ALLENDALE CHARTER TOWNSHIP
PLANNING COMMISSION MEETING

RE: Miedema Metal Building Systems - 4900 Allen Park
Site Plan Revision for Planning Commission Review

To: Allendale Charter Township Planning Commission
From: Gregory L. Ransford, MPA
Date: April 15, 2026
Re: 4900 Allen Park Site Plan Review Application – Preliminary Review

To: Allendale Charter Township Planning Commission
From: Gregory L. Ransford, MPA
Date: April 15, 2026
Re: Wesco Special Use Application – Preliminary Review

TRUCK TURNING TEMPLATE #1

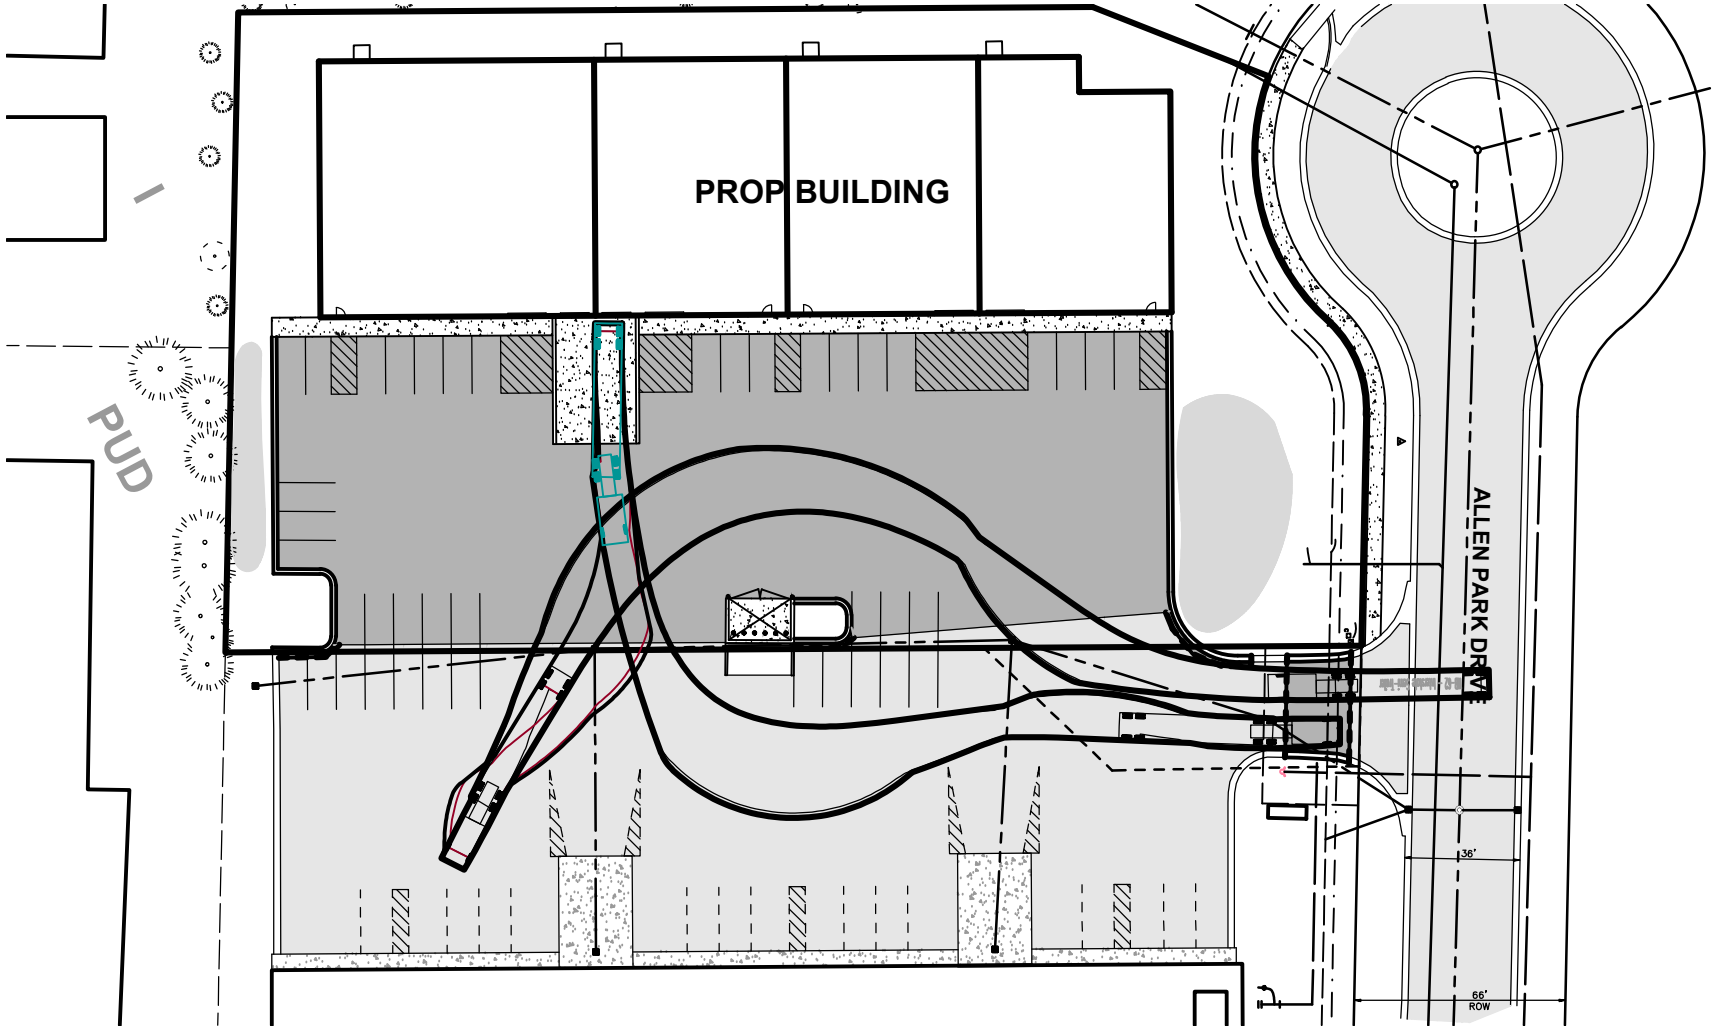
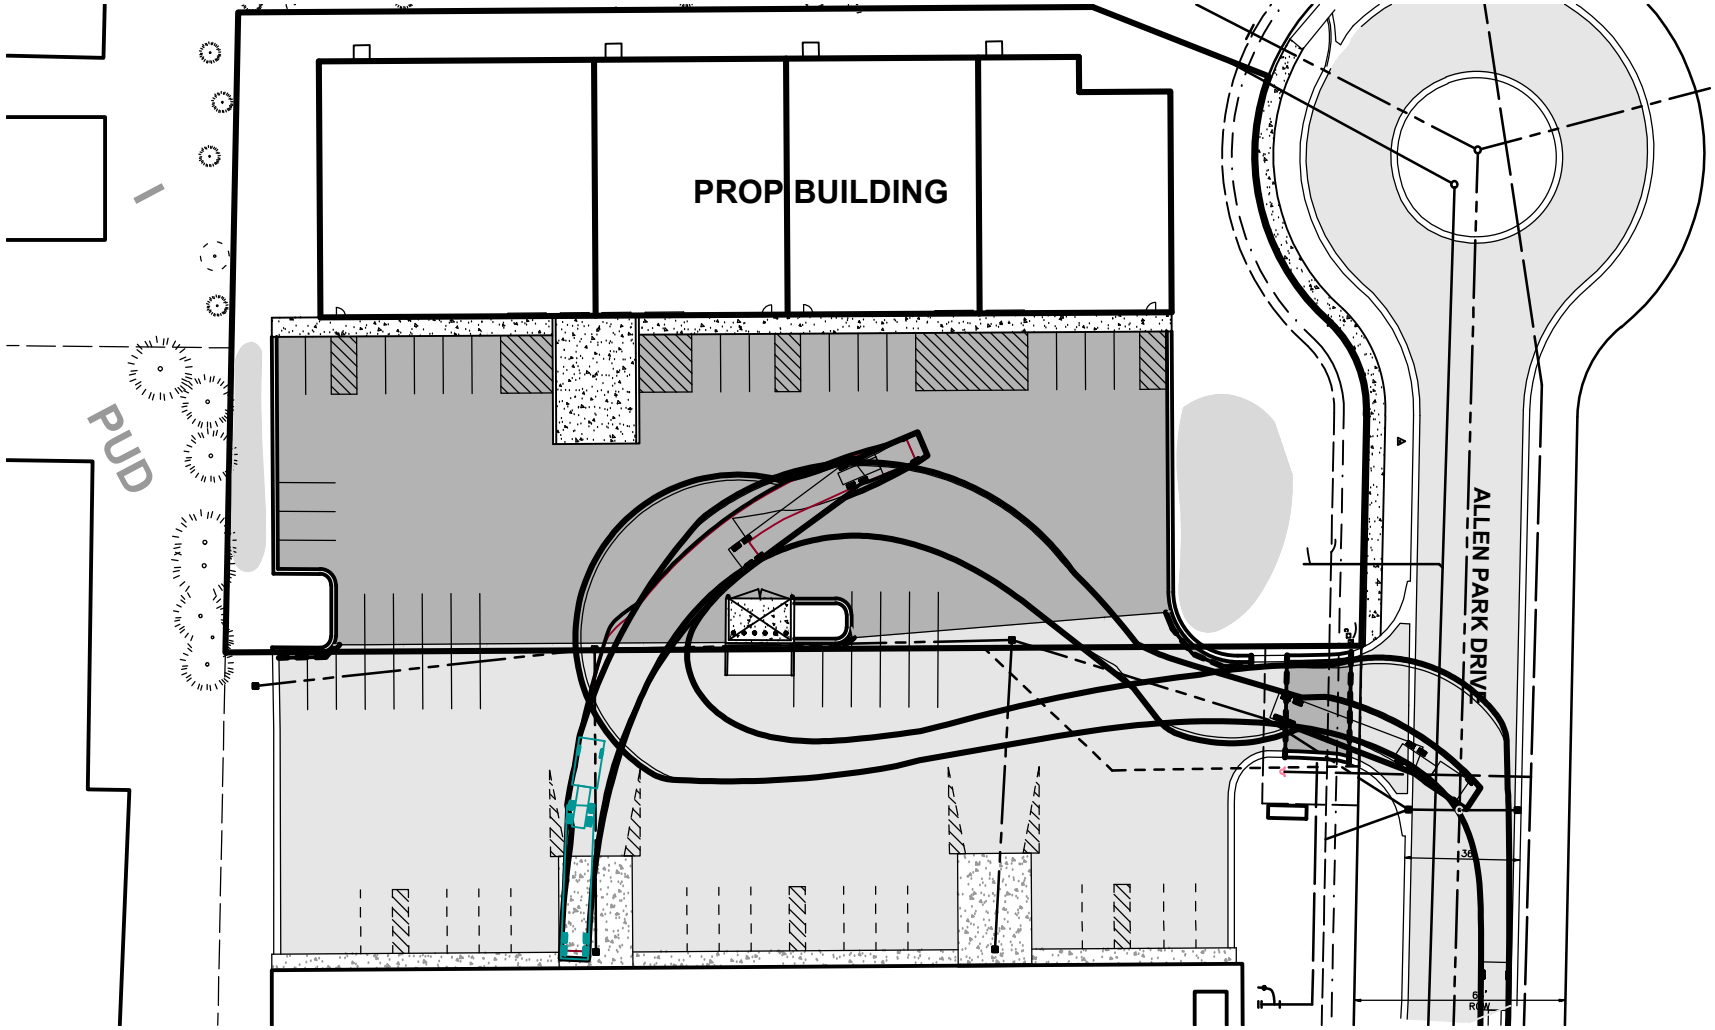
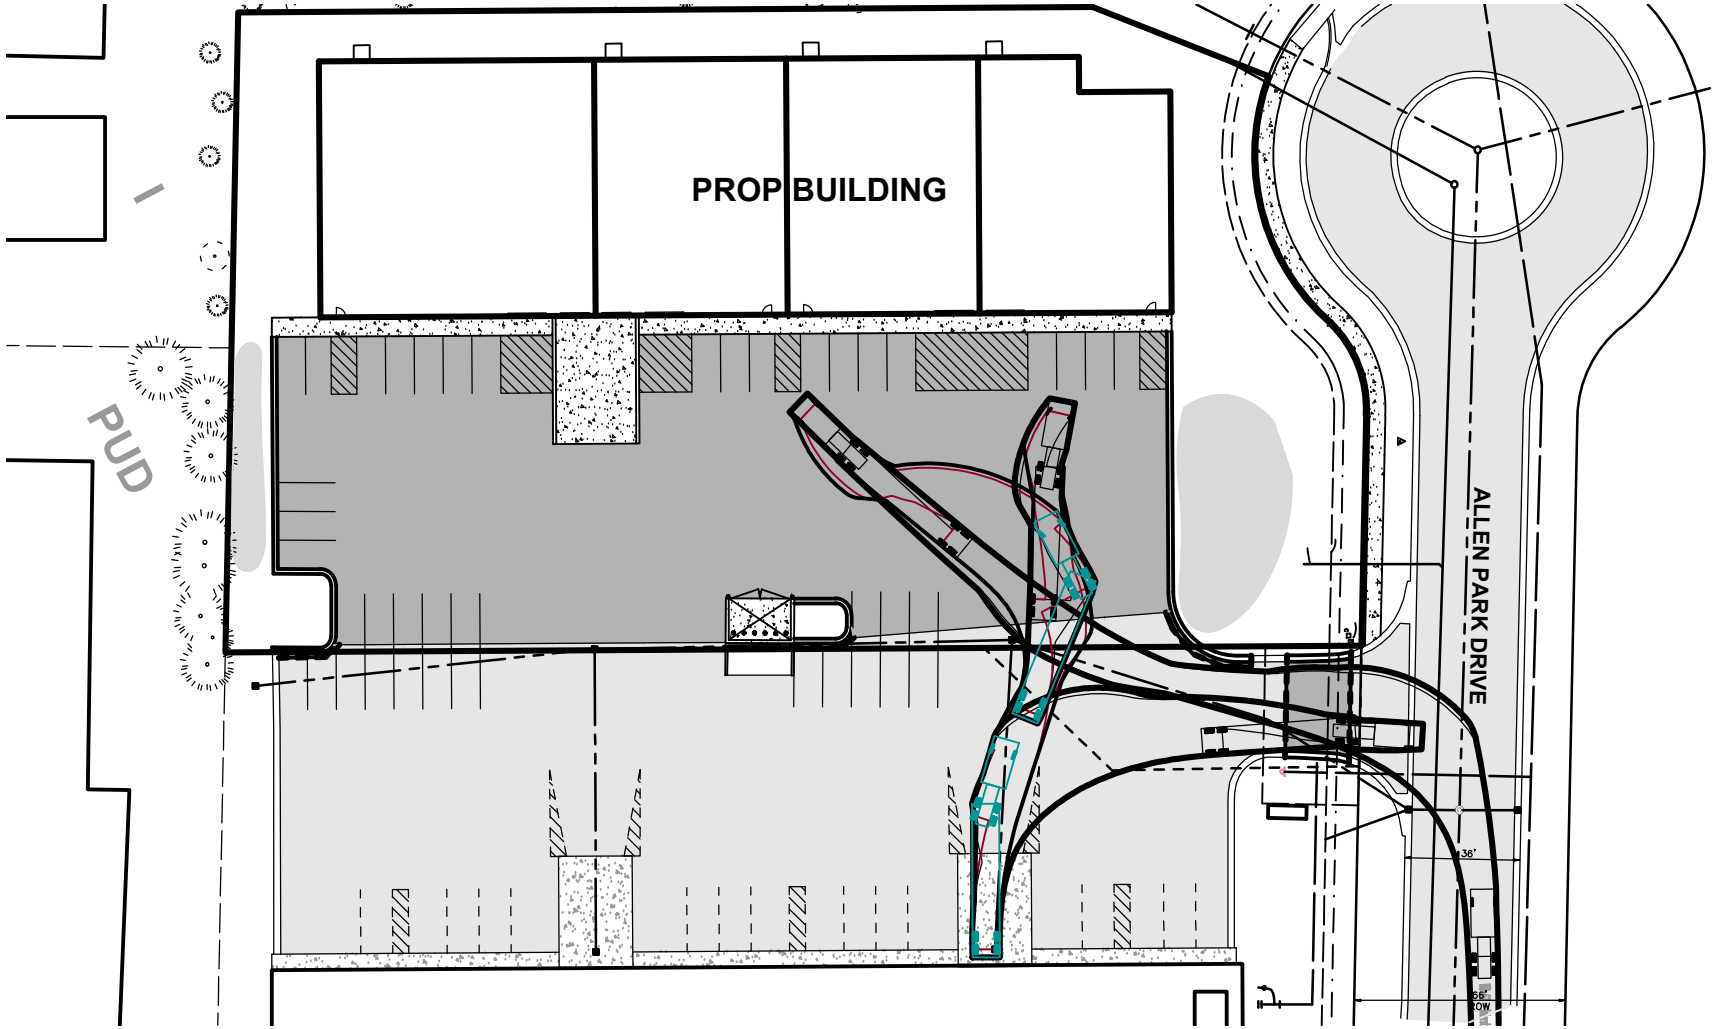
3. Provide the current zoning of all abutting properties.
4. Call out the turning radii for each turn to ensure fire trucks can make the turns.
5. Provide Allendale Charter Township specific details for water main and water service installation. This can be addressed during the construction plan development.
